Remarks

Response to Office Action

FIG. 2a

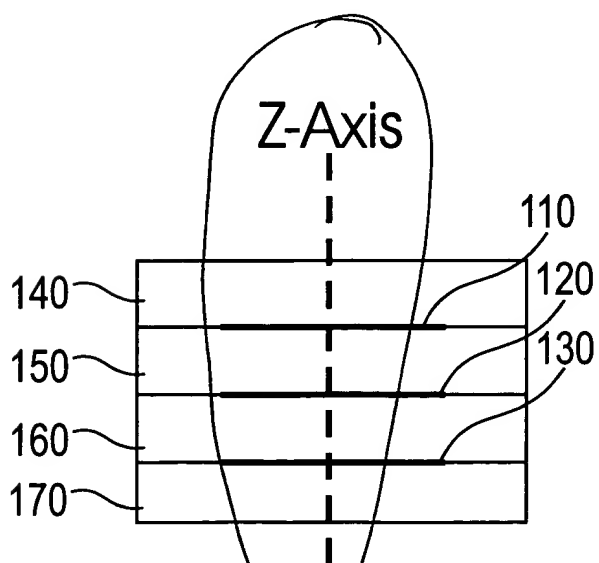
The drawings are objected to because of the following: In fig. 2a, the --Z axis--needs to be shown;

A replacement drawing has been provided showing the "Z-axis".

FIG. 12

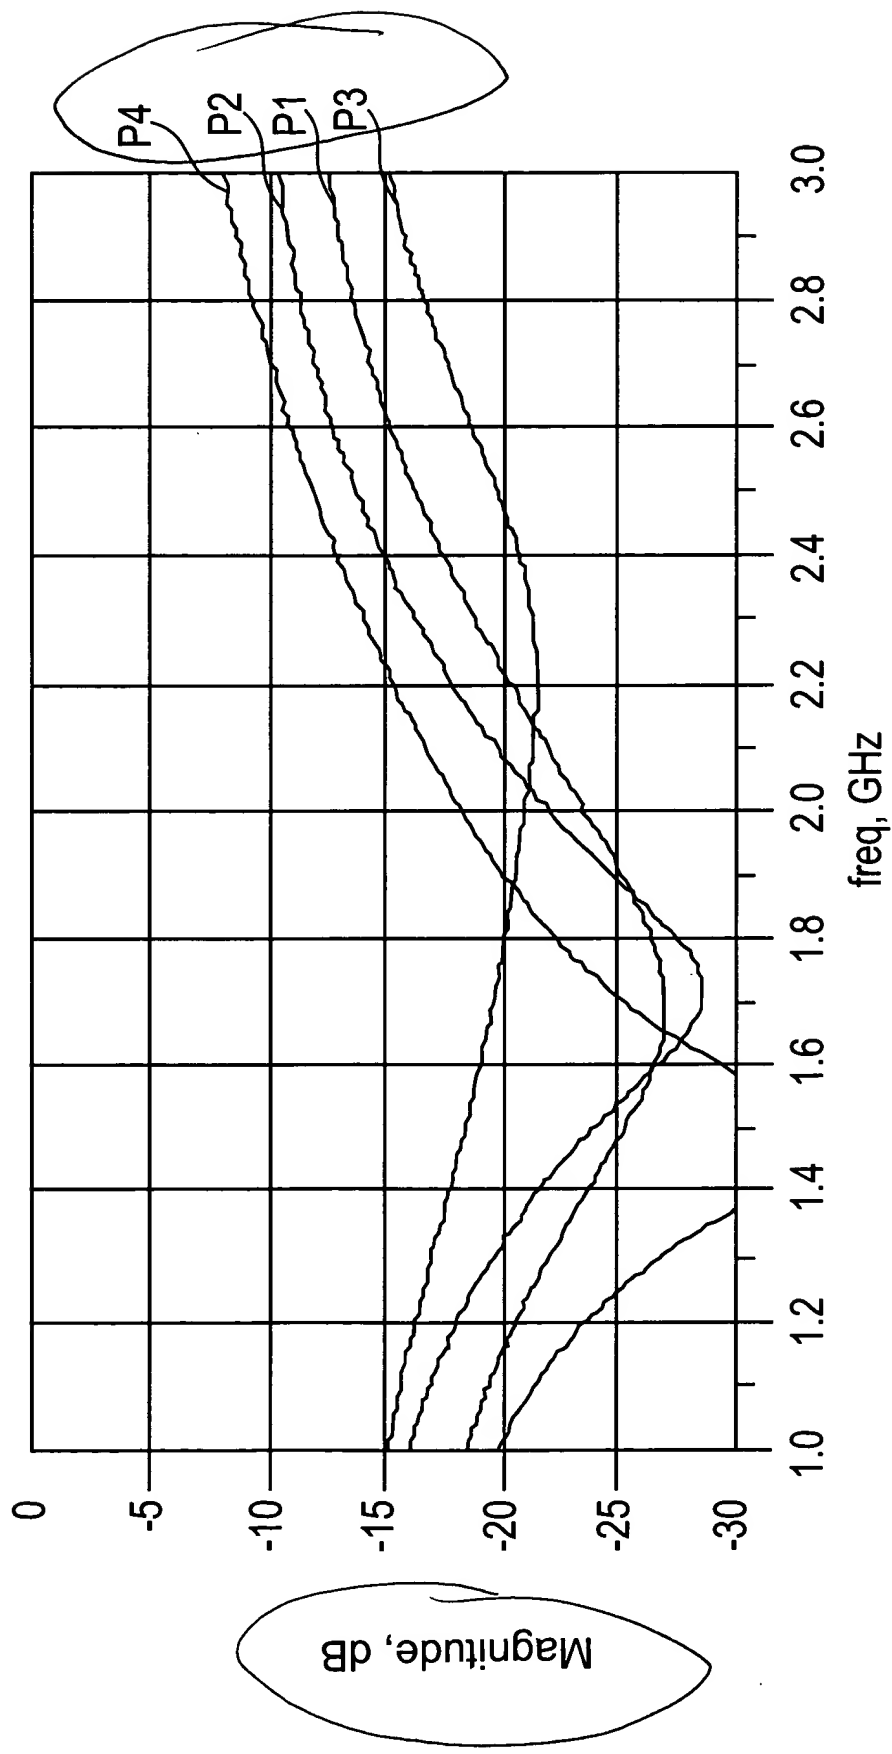
In figs. 12-17, note that (P1, P2, P3, P4) need to be labeled as per the specification description (see p 13, ls 21-26);

Replacement drawings have been provided with labeling P1, P2, P3, P4 added as appropriate.
